RETREAT AT PRAIRIERIDGE FILING NO. 1

CONSTRUCTION PLANS

FEBRUARY 2025

TITLE SHEET

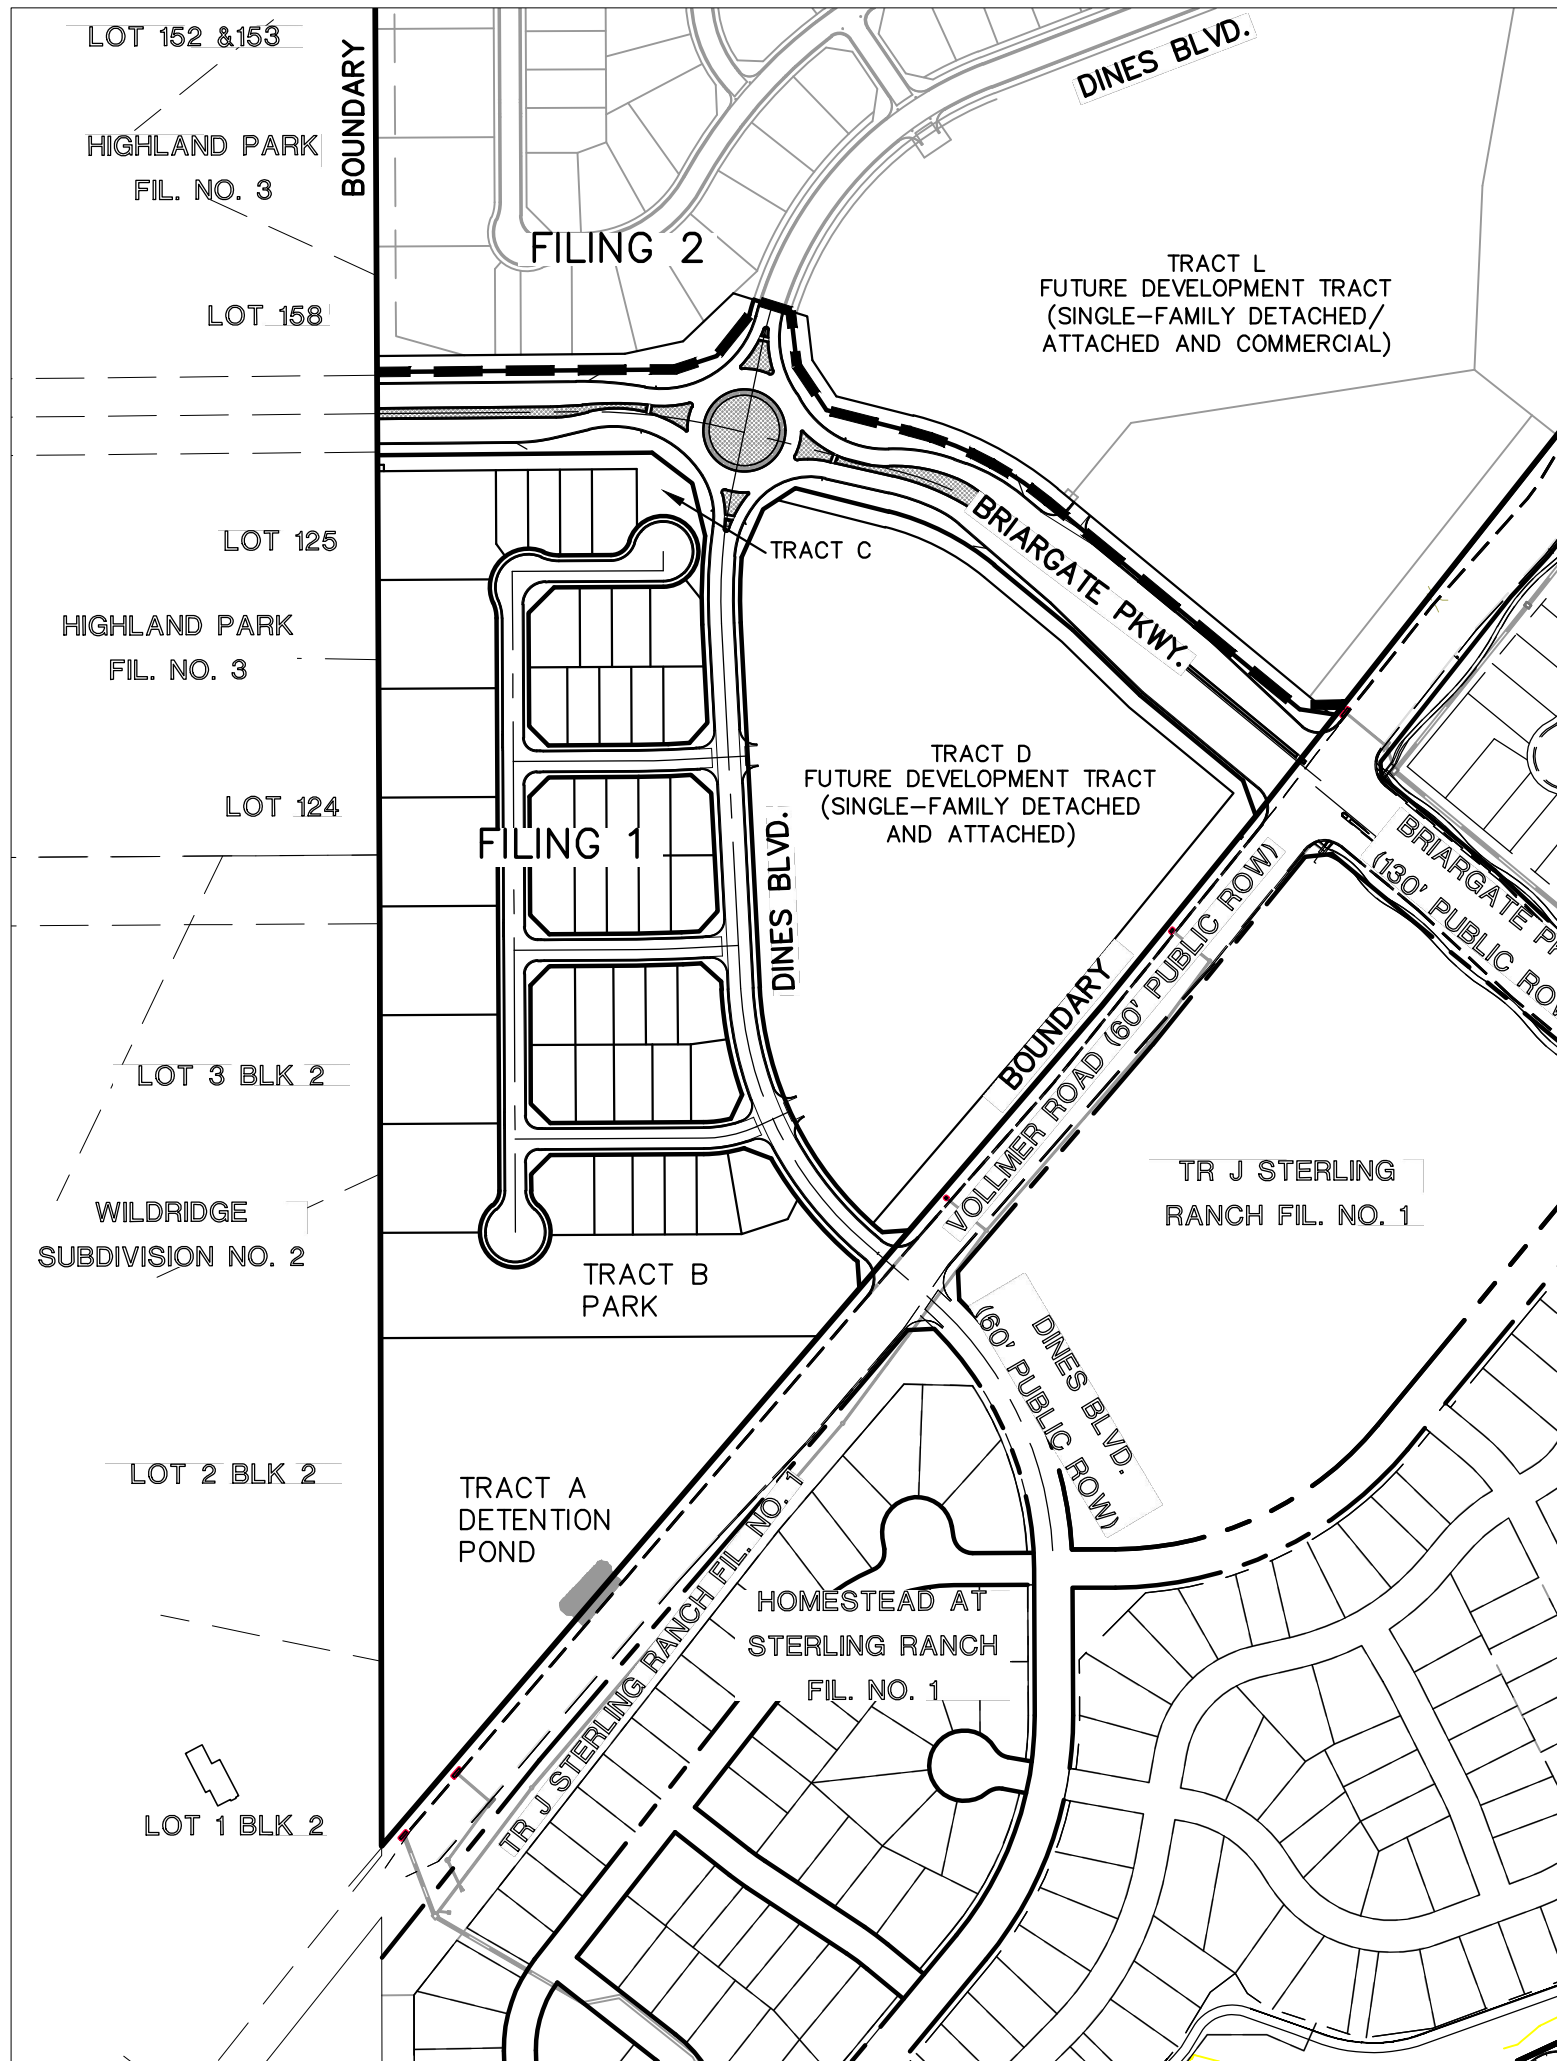
Please provide Utility construction drawings

PUBLIC STREET IMPROVEMENT PLAN
ROUND ABOUT PROFILES

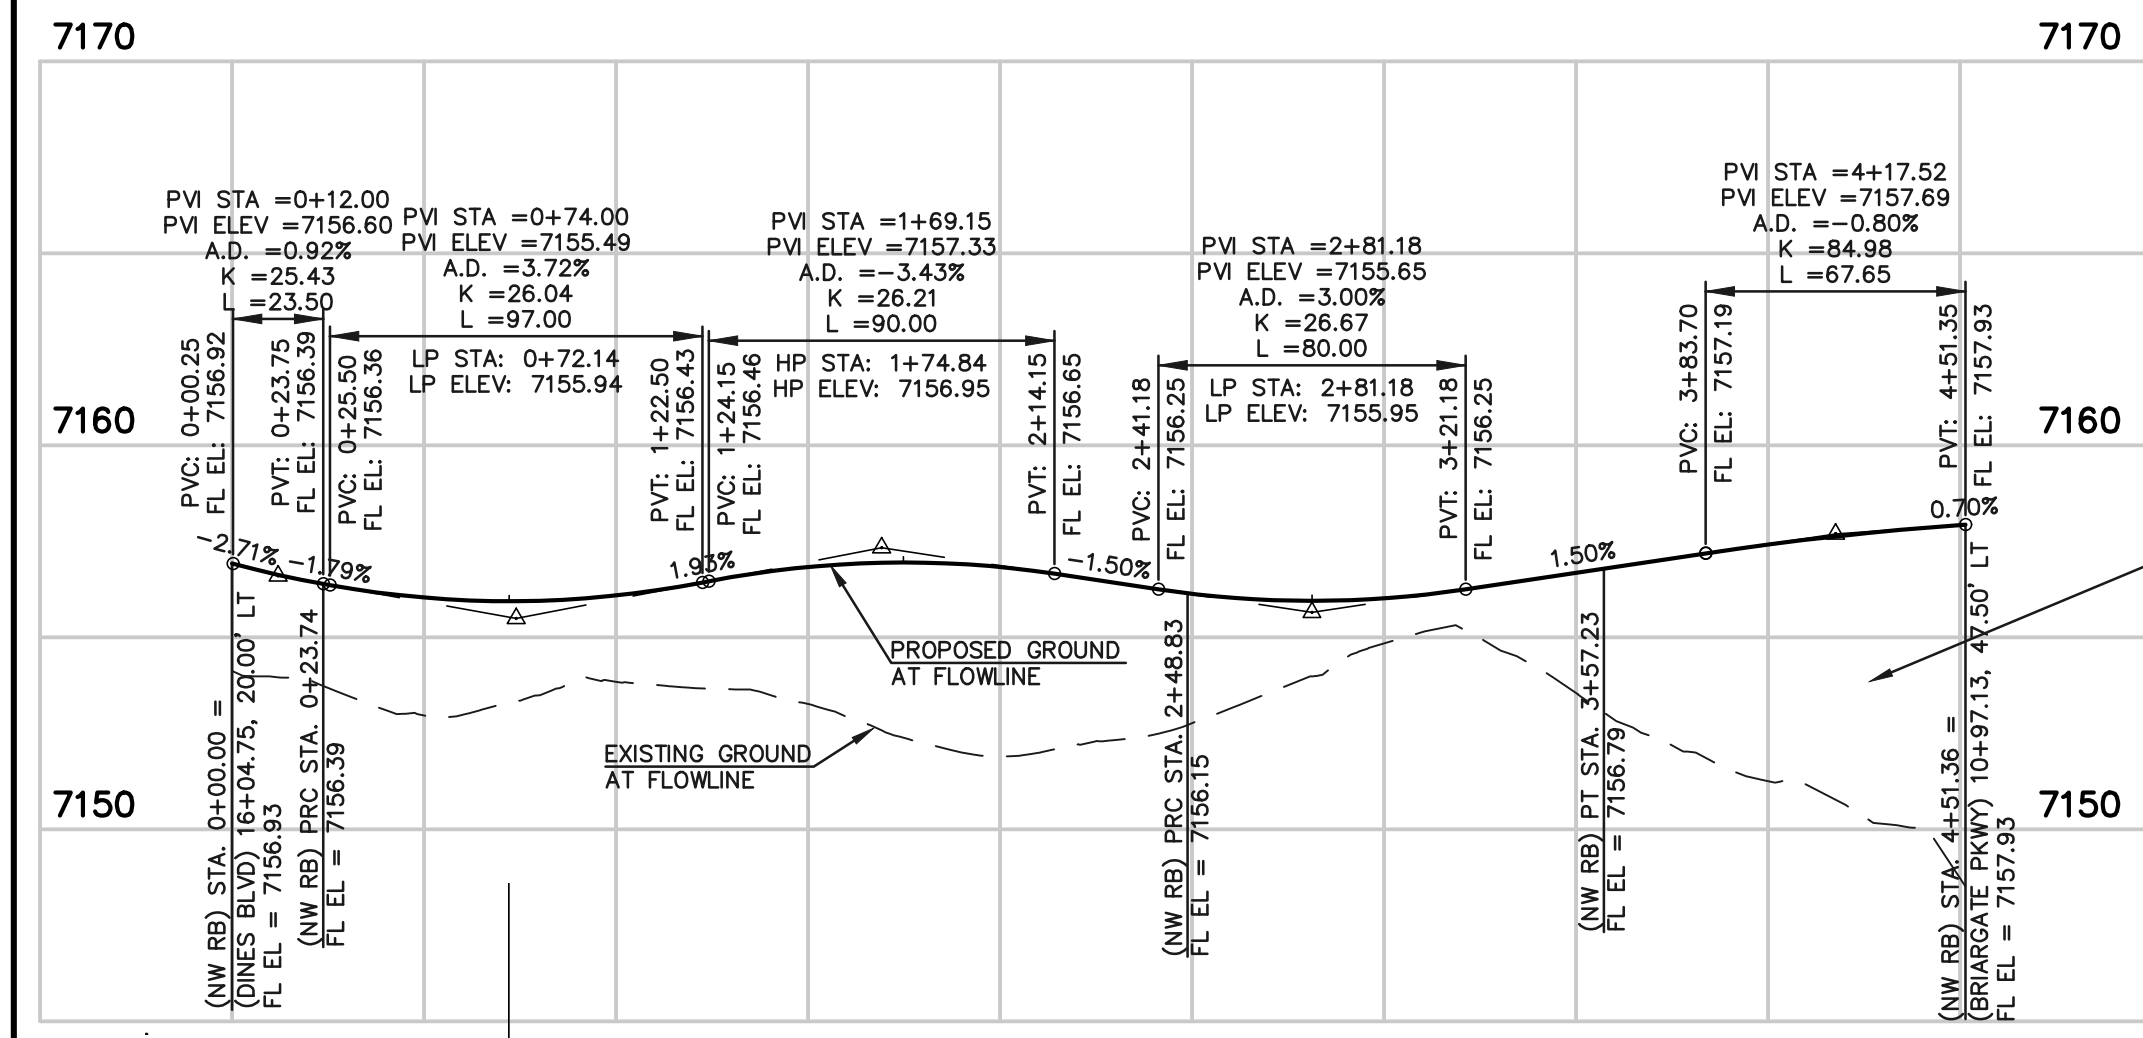
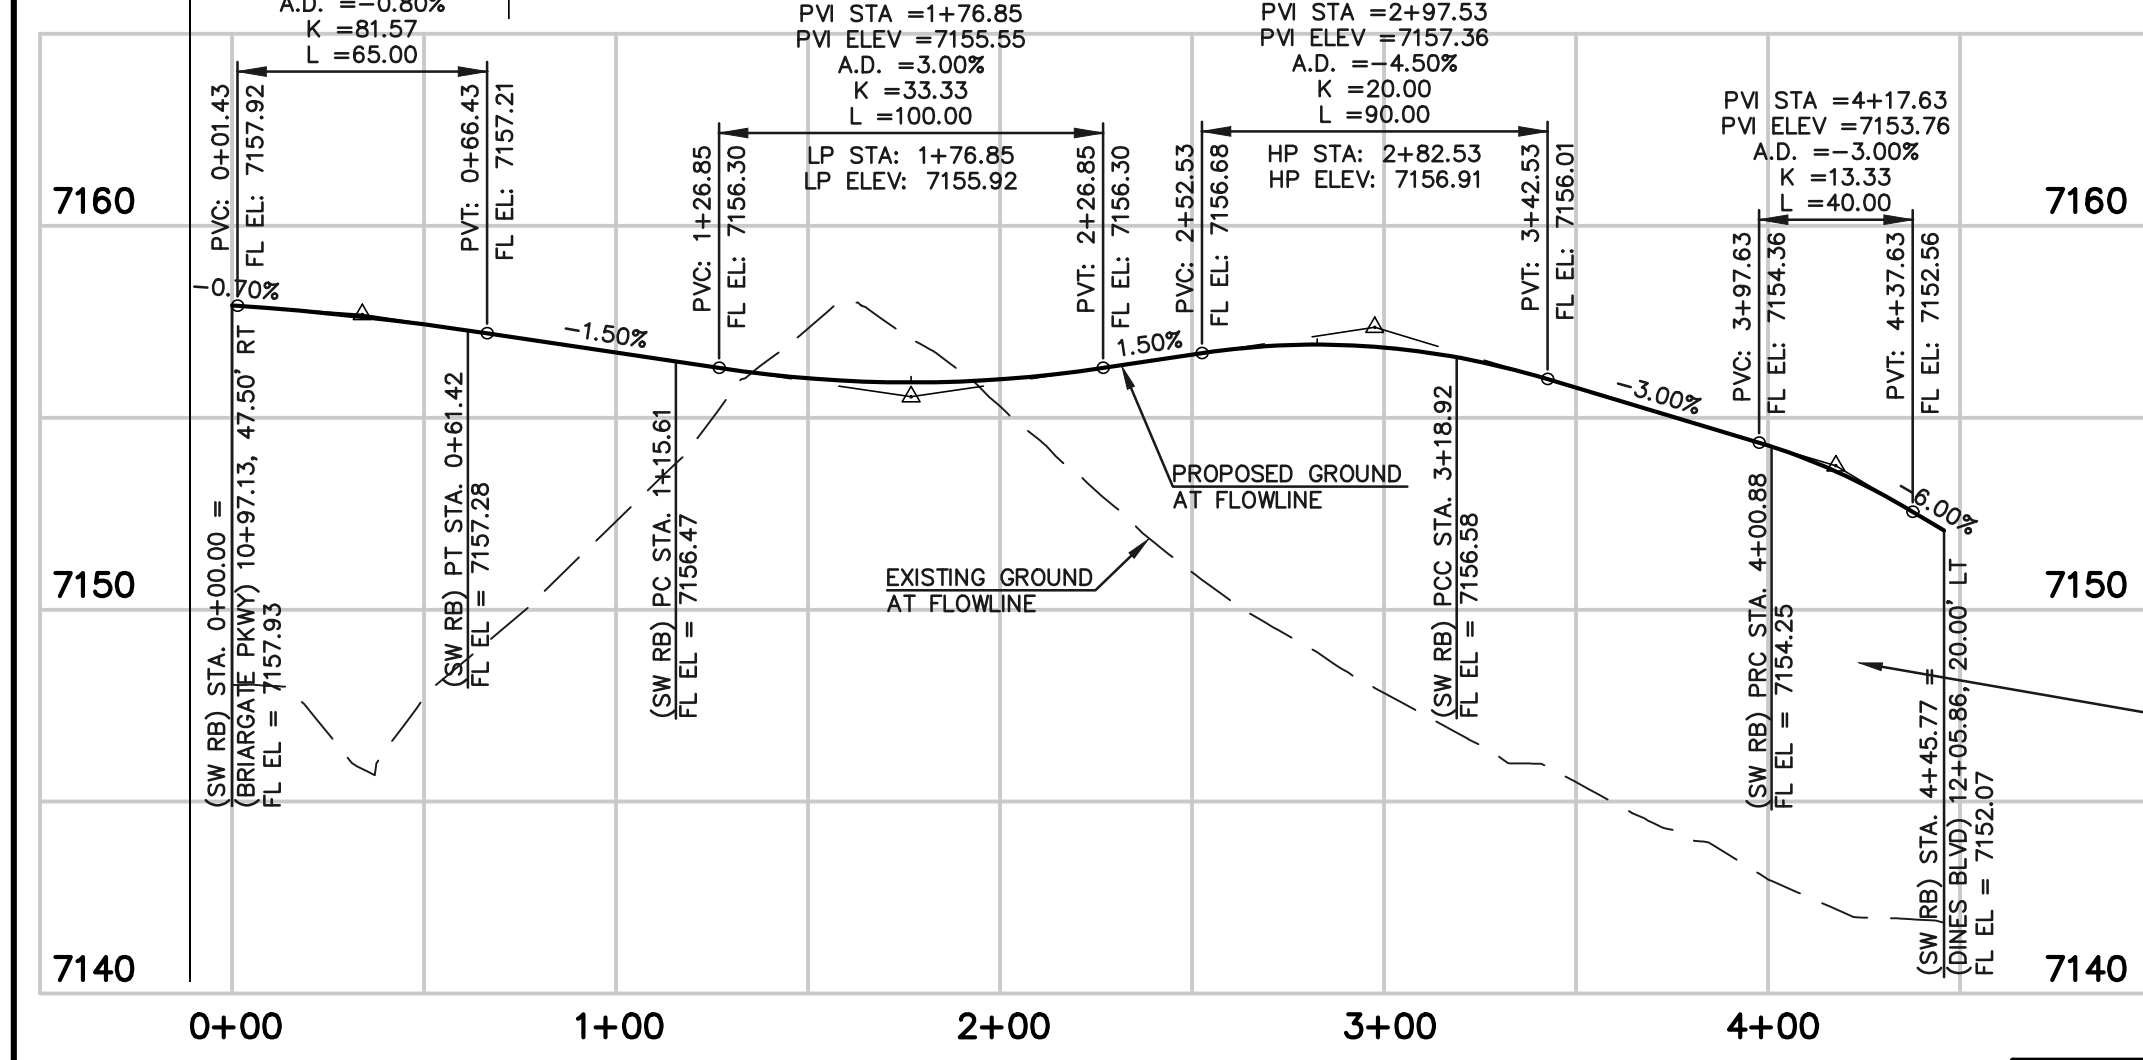
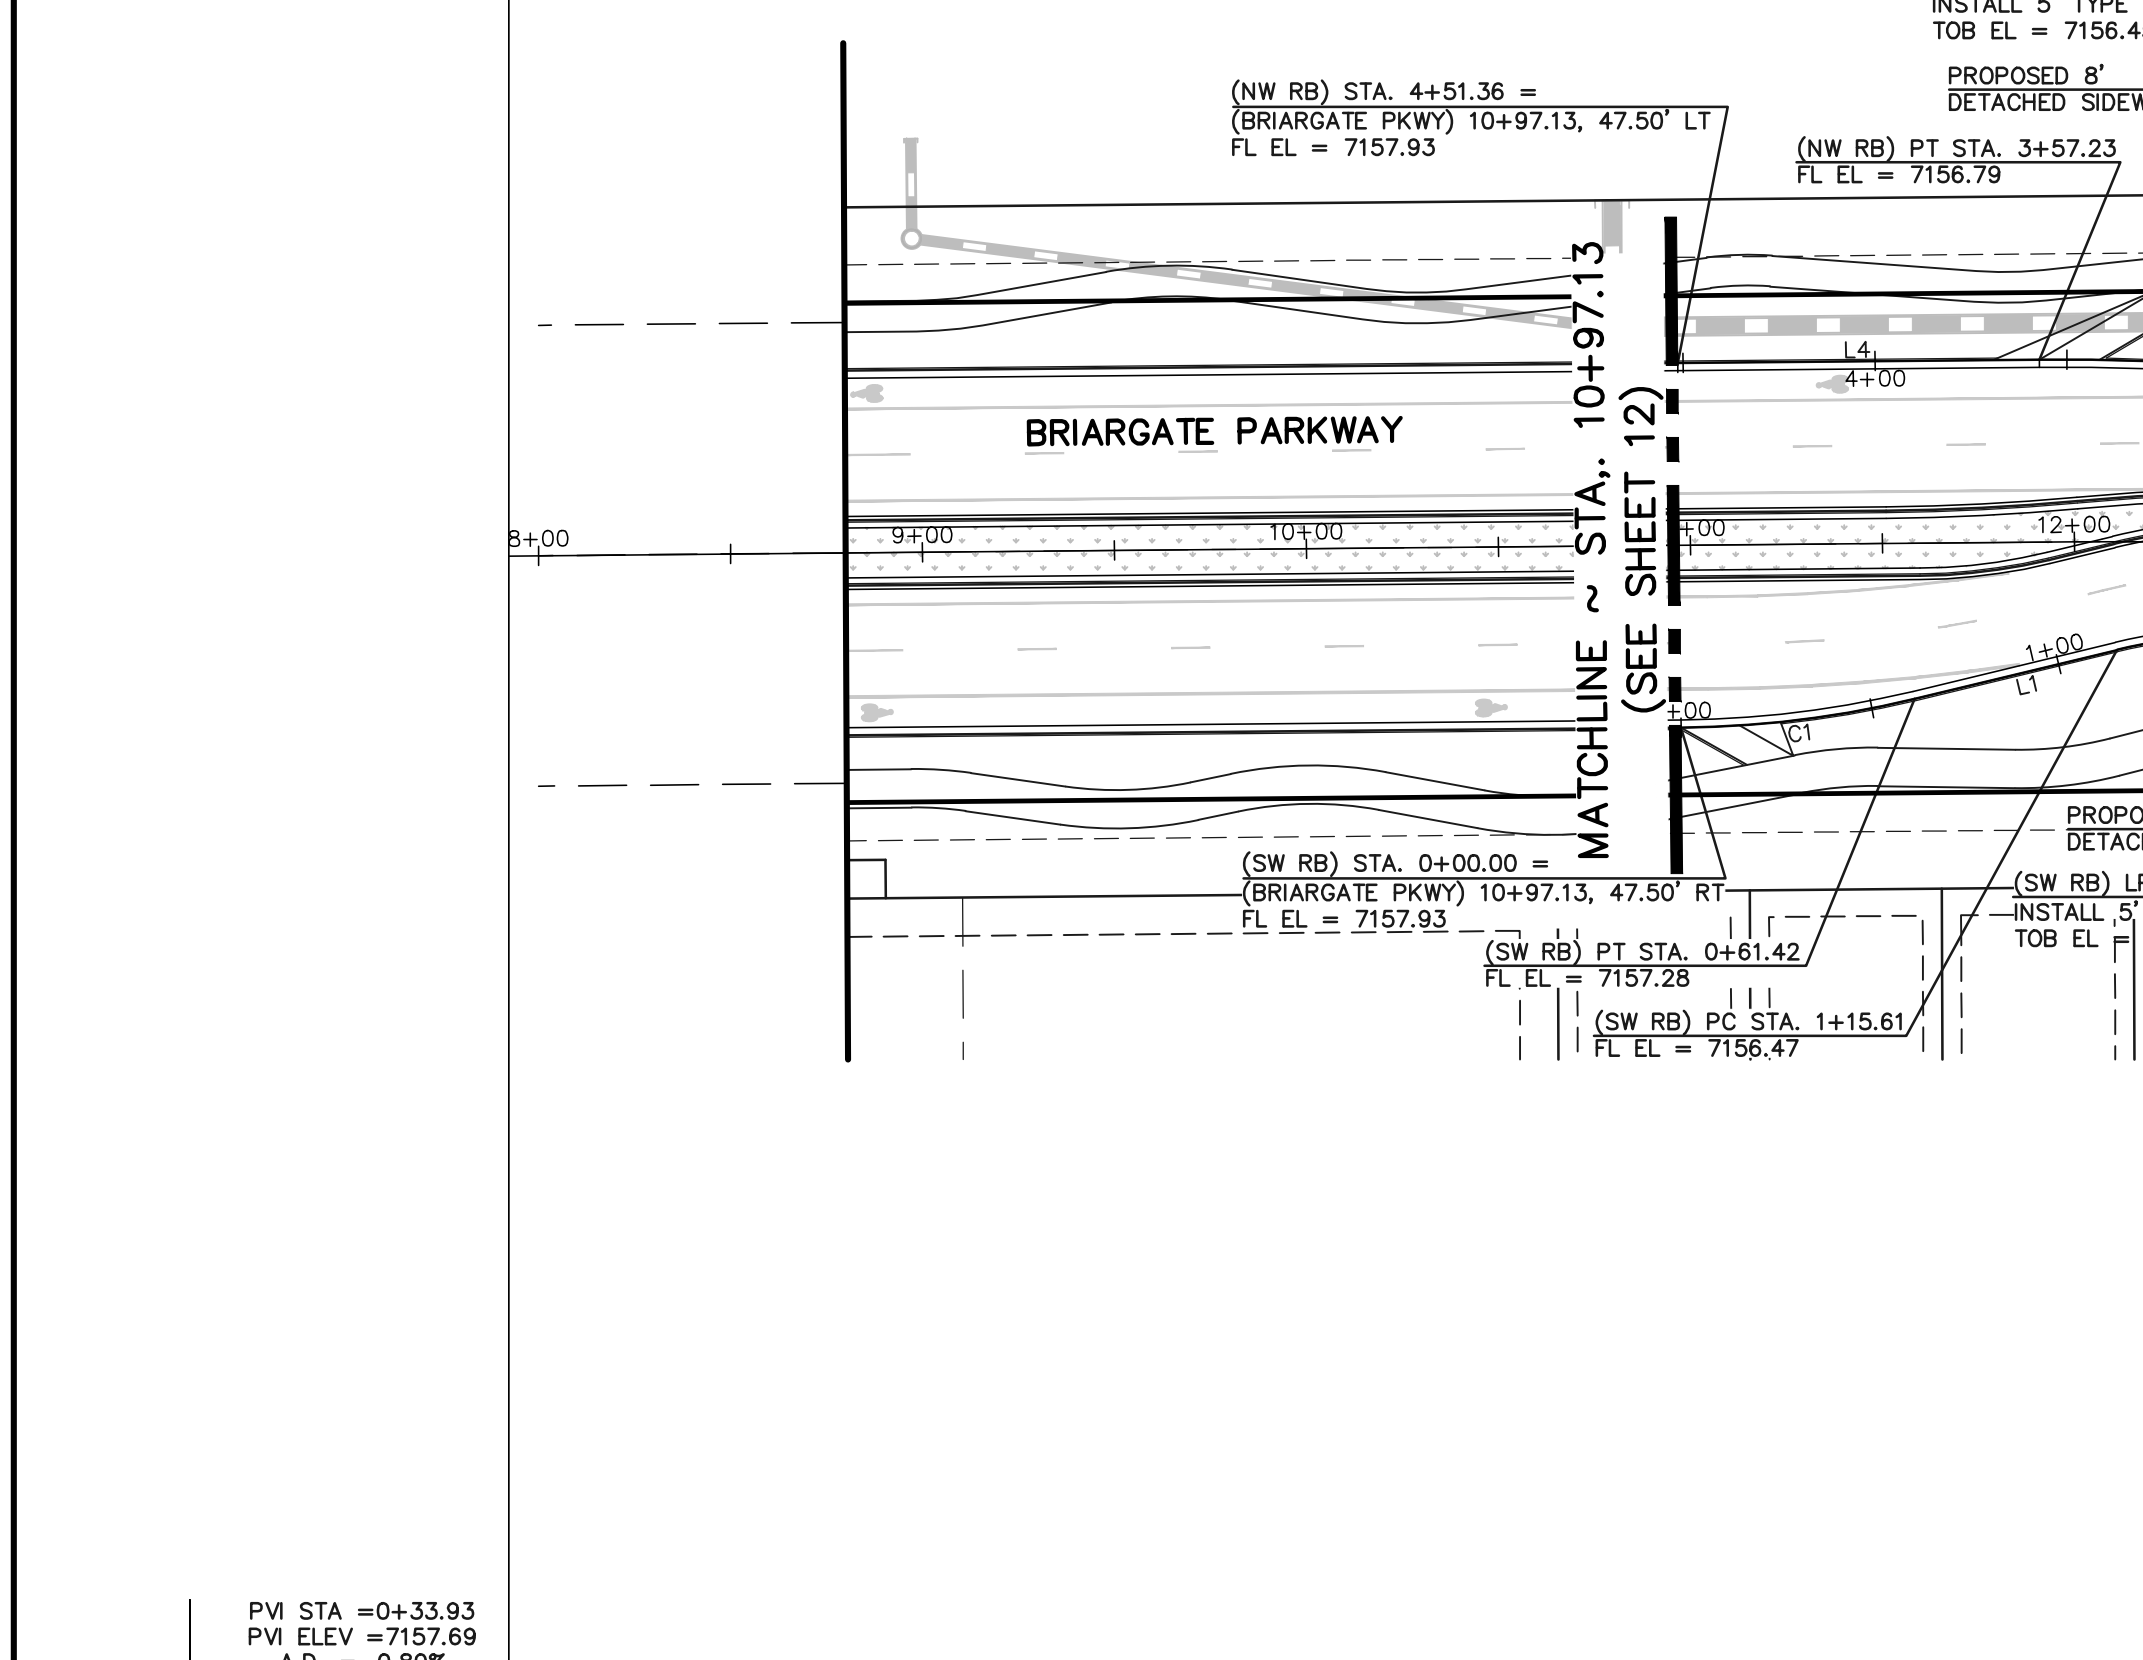
Detailed review to be provided once the roundabout design report has been submitted.
